Architectural Design Review Board
July 18, 2023 @ 4:00 p.m.
Council Chambers
First Floor, 345 High Street
Hamilton, Ohio 45011

To: Architectural Design Review Board
From: Dani Baxter
Subject: New Business - AGENDA ITEM #1
117 S B St – Porch Step Replacement
Tracy Wieland, Applicant
Meeting Date: July 18, 2023
Received Application: June 21, 2023
Impacts: Rossville-Main Historic District

Exhibit C – Site Plan & Photos

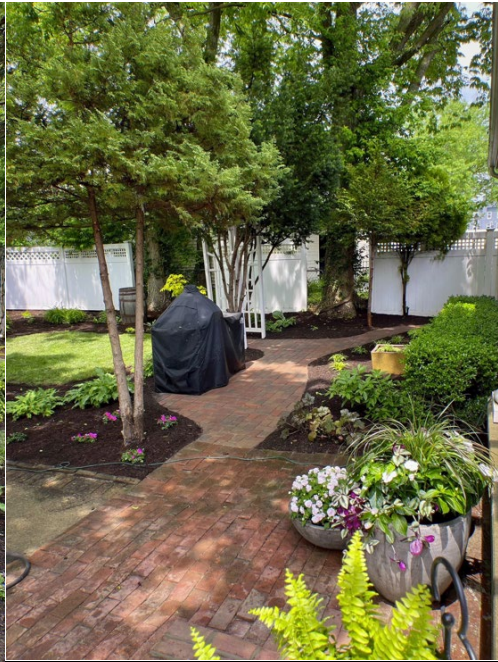
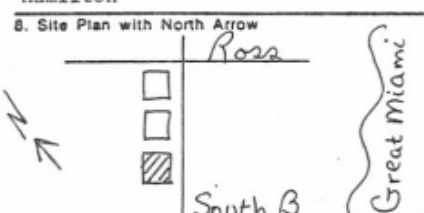
1. The existing home is painted brick.
2. Applicant is proposing to match brick steps with brick already installed throughout the property.
3. Secondary entrance has temporary wood steps covering the existing concrete steps due to safety concerns.
4. Phase 1 includes constructing new concrete steps and wrapping them in brick at the secondary entrance.
5. Phase 2 includes wrapping the existing front porch steps in brick to match.
6. Main patio pads and walkways will remain concrete.
